Project	IEEE 802.16 Broadband Wireless Access Working Group < http://ieee802.org/16 >	
Title	Enhanced Pilot allocation of PUSC in downlink STC that can be compatible with Non-STC	
Date Submitted	2005-02-20	
Source(s)	Authors: xia shu qiang , Lin jia shi ZTE Inc. Address	Voice: Fax: E-mail: xia.shuqiang@zte.com.cn lin.jiashi@zte.com.cn
Re:	Response to the call for comments 802.16maint-04/10 Corrigendum to IEEE 802.16-2004	
Abstract		
Purpose	Adopt proposed changes to TGMaint document	
Notice	This document has been prepared to assist IEEE 802.16. It is offered as a basis for discussion and is not binding on the contributing individual(s) or organization(s). The material in this document is subject to change in form and content after further study. The contributor(s) reserve(s) the right to add, amend or withdraw material contained herein.	
Release	The contributor grants a free, irrevocable license to the IEEE to incorporate text contained in this contribution, and any modifications thereof, in the creation of an IEEE Standards publication; to copyright in the IEEE's name any IEEE Standards publication even though it may include portions of this contribution; and at the IEEE's sole di

Figure-3: Proposed pilots scheme for STC two antenna systems

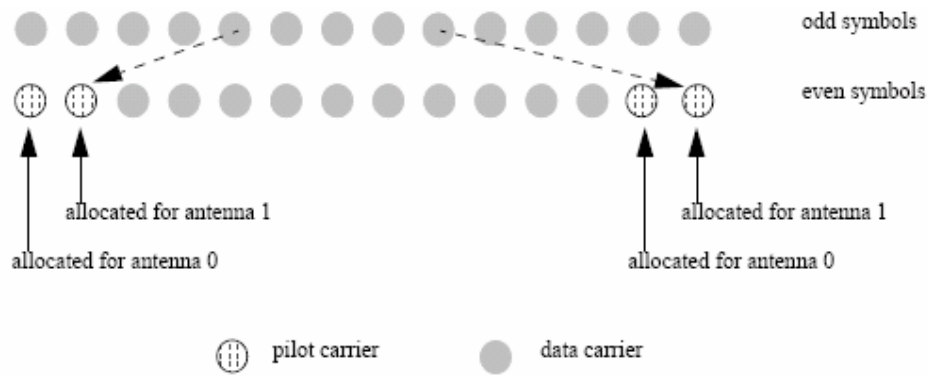
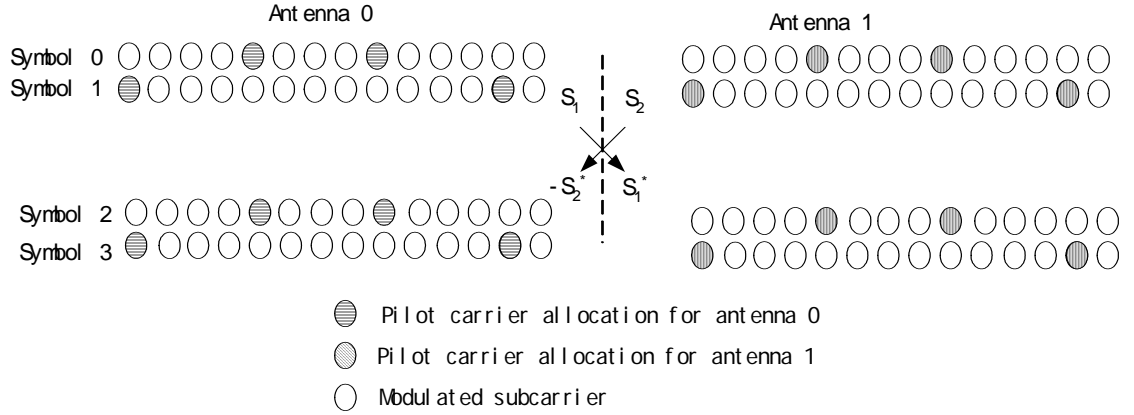
According to figure-1 and figure-2, we can find the pilots spacing is 12 carriers for each antenna and inequation (1) is not satisfactory. Hence, we propose one improved pilot allocations for two and four antennas, respectively

For two antennas, pilot locations within the cluster shall be defined depending on the symbol index within each quartar of symbols, as following:

Replace figure 245 with Figure-3.
 Replace figure 246 with Figure-5.

Figure-4: Proposed pilots scheme for STC four antenna systems

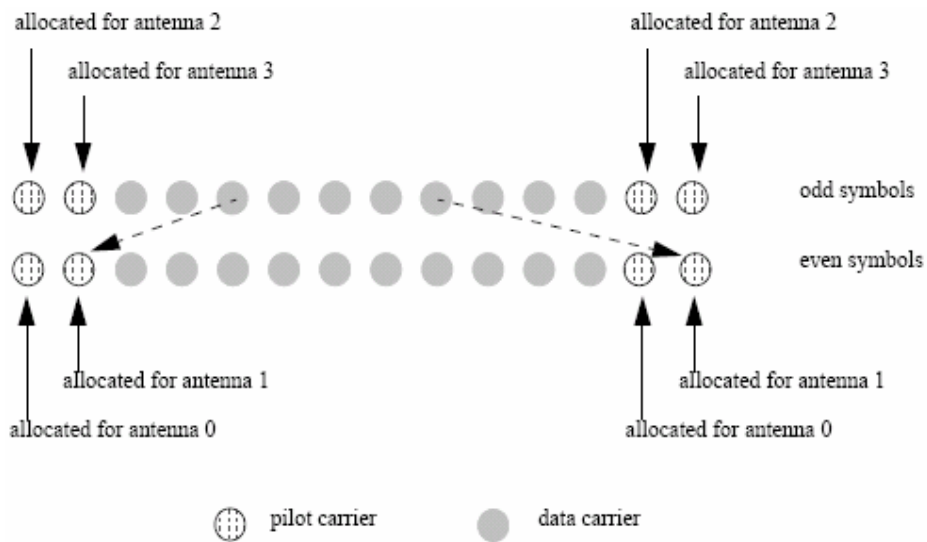
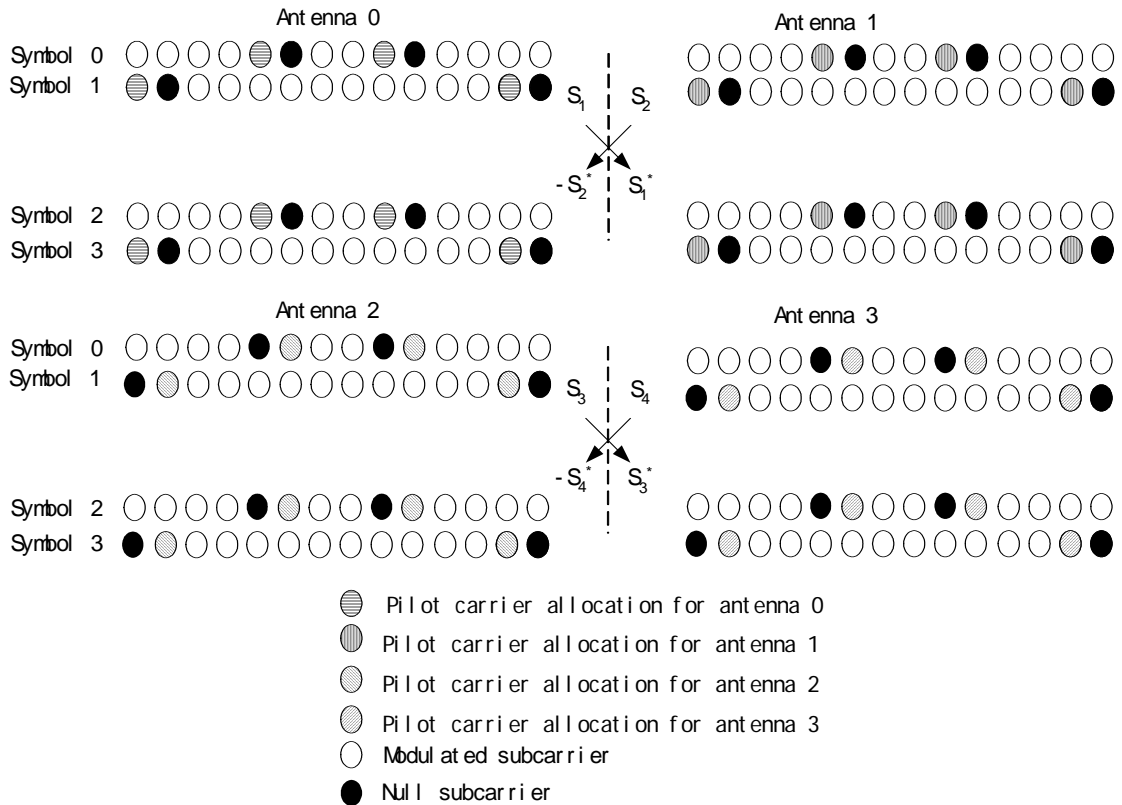
The scheme mentioned above can also be extended to four antennas. For four antennas, the carriers is allocated as following figured. It should be noted that the data subcarriers which overlap with pilots allocated to antennas 2,3 are punctured.

Compared with the pilot allocation currently in 80216-2004, 3dB gain in SNR can be obtained based our proposal because pilots are encoded in our scheme. What is more, our scheme is compatible with non-STC mode. When we insert the pilot into the symbol, after STC, it can be convert the sign of pilot set automatic. For example, according to the above matrix of formula(3). Firstly, the antenna 0 and antenna 1 transmit pilot set P; secondly, antenna 0 transmits the pilot set -P and antenna 1 transmits the pilot set P, and the conversion can be realized automatic with STC. So, by the way can we improve the performance of channel estimation and realize the channel estimation more easy.

Replace figure 251 with Figure-4.

For this configuration the basic cluster structure is changed as indicated in Figure 251 to accommodate the transmission from 4 antennas (pilots for antennas 2/3 override data subcarriers in the even symbols and odd symbols, erasing of the data subcarriers shall be performed after constellation mapping, therefore maintaining all the encoding scheme and the subchannel allocation scheme).
